Access Compliance Report
Public Rights-of-Way
(Curb Ramps)

Intersection ID: N/A | **Main Street:** TYVOLA_RD | **Cross Street:** SPEER_BV | **Location:** S

ADA ID: 6C12BC0D5B2A | **Ramp Type:** Perp | **Initial Pass/Fail:** Fail | **Overall Compliance:** No | **Severity Score:** 21.25

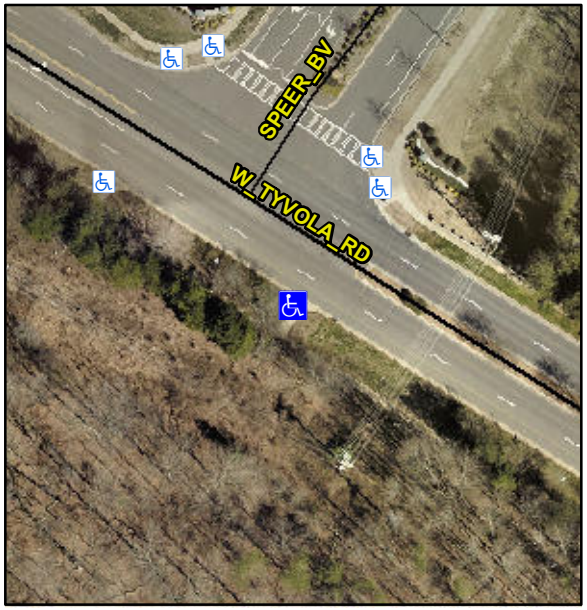
Not Found, R304.5.1, R304.2.2

Compliance	Description	Data	Compliance	Description	Data
N/A	Ramp Length (in)	62.5	No	Ramp Slope (%)	10.0
No	Ramp Width (in)	46.5	Yes	Ramp XSlope (%)	0.8
N/A	Flare Type LT	N/A	N/A	Flare Type RT	N/A
N/A	Flare Slope LT (%)	N/A	N/A	Flare Slope RT (%)	N/A
N/A	Flare Traversable LT?	N/A	N/A	Flare Traversable RT?	N/A
N/A	Landing Length (in)	N/A	N/A	DWS Provided?	N/A
N/A	Landing Width (in)	N/A	N/A	DWS Contrast?	N/A
N/A	Landing Slope (%)	N/A	N/A	DWS Length (in)	N/A
N/A	Landing X Slope (%)	N/A	N/A	DWS Full Width?	N/A
N/A	Landing Curb? (Y/N)	N/A	N/A	DWS Offset (in)	N/A
N/A	Shared Landing?	N/A			
N/A	Gutter Ponding?	N/A	N/A	Gutter Slope (%)	N/A
N/A	Gutter Lip Ht (in)	N/A	N/A	Gutter X Slope (%)	N/A
N/A	Painted X Walk1?	No	N/A	Painted X Walk2?	N/A
	X Walk 1 Direction	To NE		X Walk 2 Direction	N/A
N/A	X Walk 1 Width (in)	N/A	N/A	X Walk 2 Width (in)	N/A
	X Walk 1 Slope (%)	1.8		X Walk 2 Slope (%)	N/A

Remove & Replace Entire Ramp.
